For the attention:
Phillip Zappala
Senior Planner – Major Assessment
City Development Branch
Council of City of Gold Coast

Objection submission COM/2019/81 - Groundwater Errors and Inconsistencies in DA and analysis of the long term environmental and ecological effect

Attachment A1 - Surrounding Water Levels

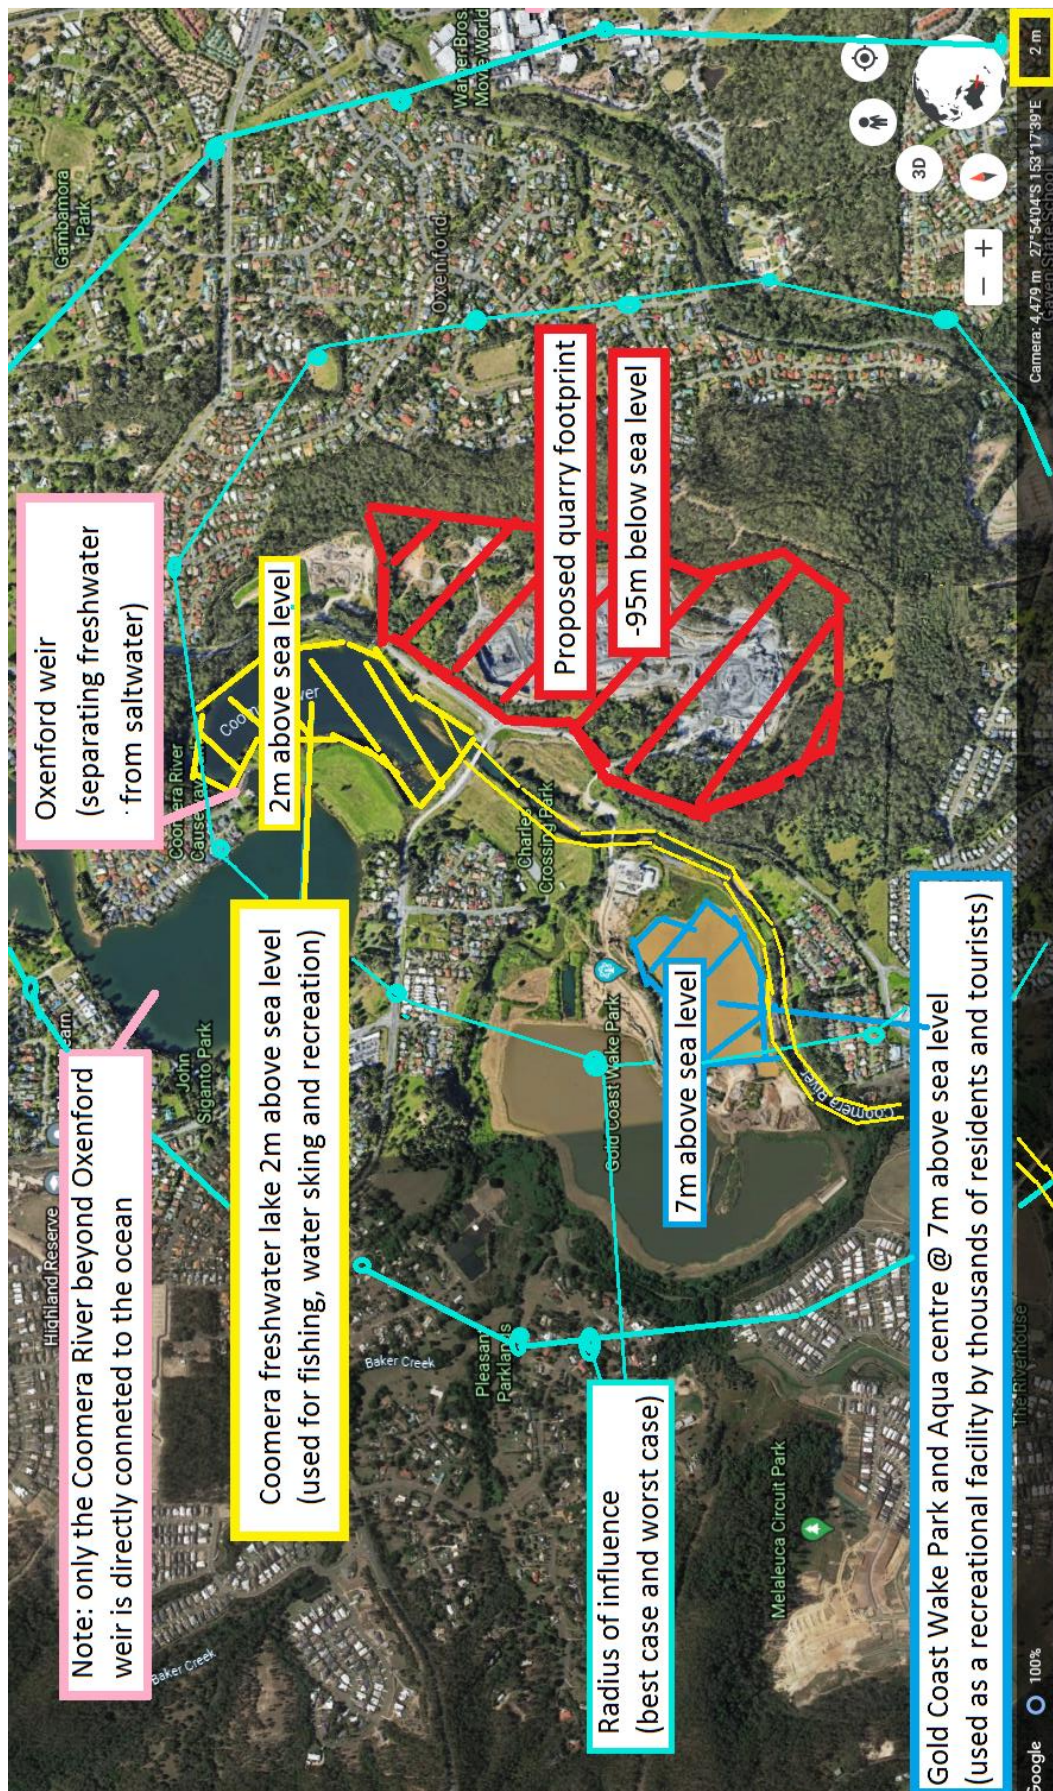
It is expected that the 'radius of influence' could be in the region of 1.4km (that's an area in excess of 6 km²) surrounding the quarry that will be potentially affected by the lowering of the water table (Attachment B3). The extent of this can be seen on the map in Attachment A1.

The map produced in Attachment A1 shows how the groundwater ‘radius of influence’ will engulf the Coomera freshwater lake (opposite the quarry) and the Gold Coast Wake Park and Aqua Park (be it the best or worst case scenario).

River actually be drained by this much lowering of the water table throughout the area. The map in Attachment A1 clearly show the influence on the water table will be extensive.

Attachment C1 - Cross section at John Muntz Bridge

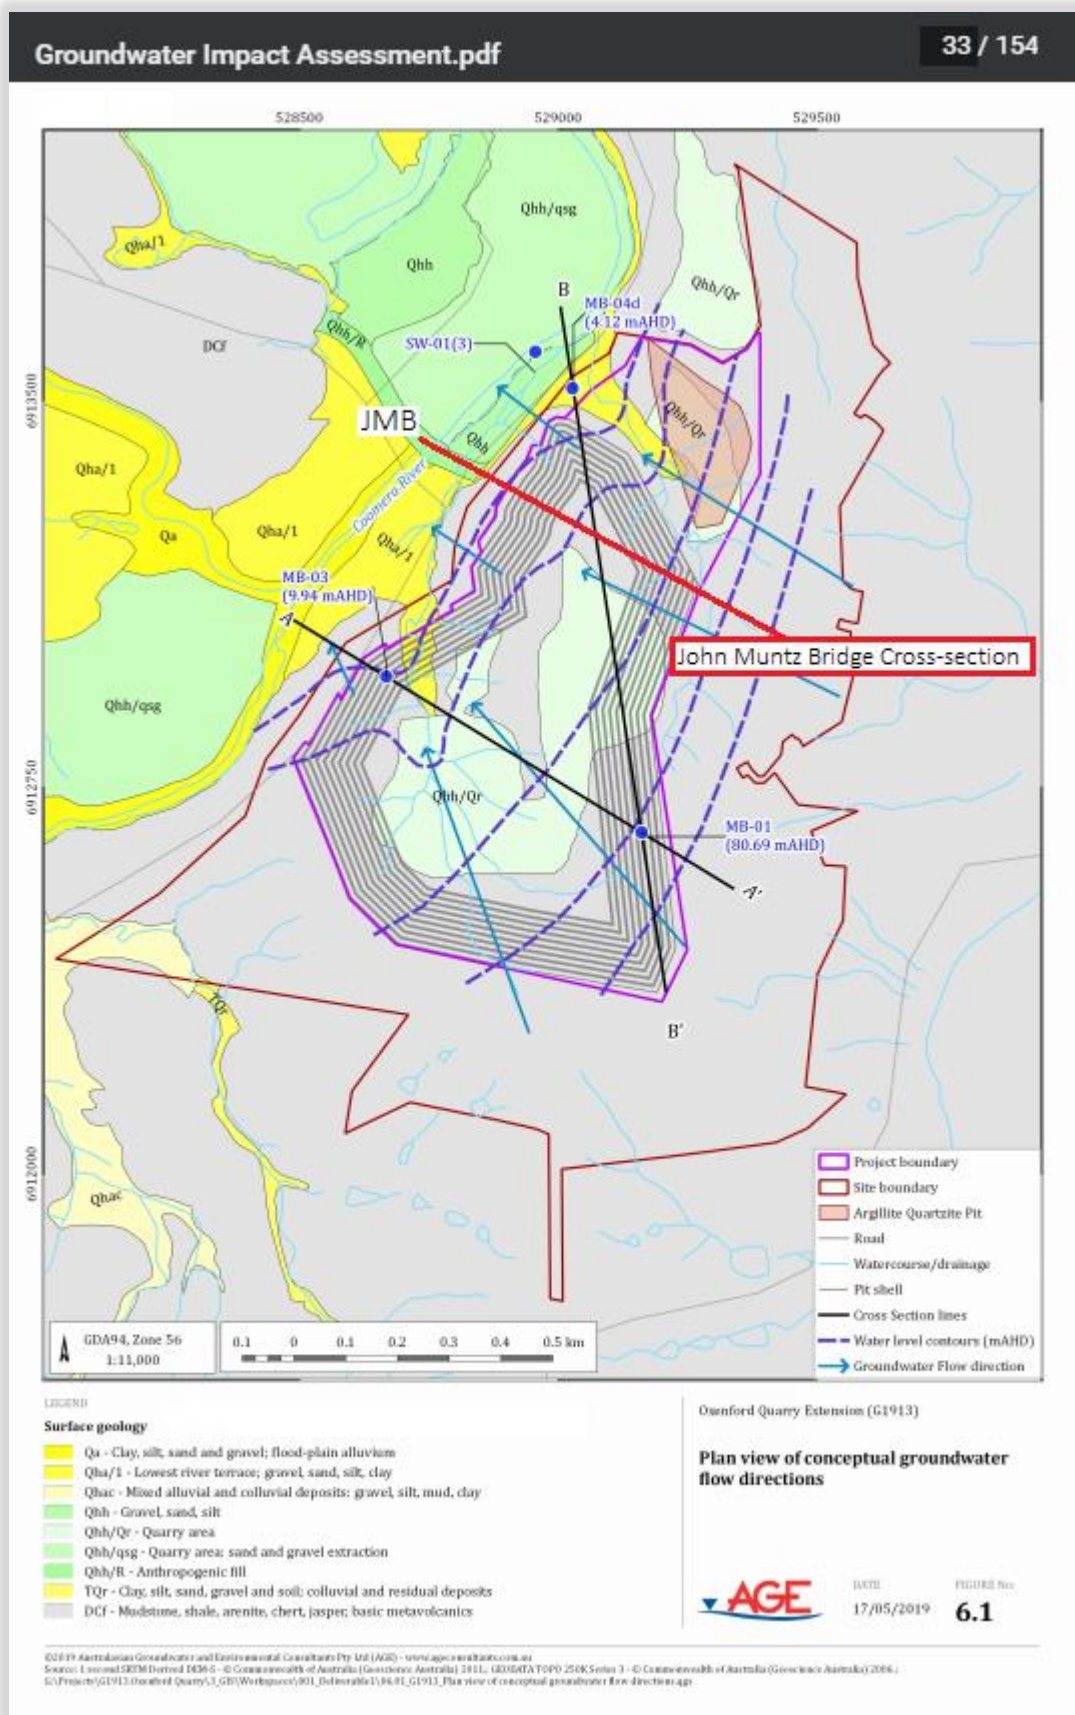
Attachment C1 shows a cross section of the quarry area at the juncture with the John Muntz bridge (as identified in Attachment C2).

This clearly shows how close the water table is reliant upon the depth of the Coomera River. Once the quarry pit goes below this level the corresponding water table around it will drop also (In fact it will drop a staggering 95 metres).

What will happen if the lowering of the water table so drastically creates a new level for the Coomera lake opposite? Will the Coomera river be able to maintain its present level given the underlying water table has been lowered substantially? How will this affect the local environment? Will the Coomera
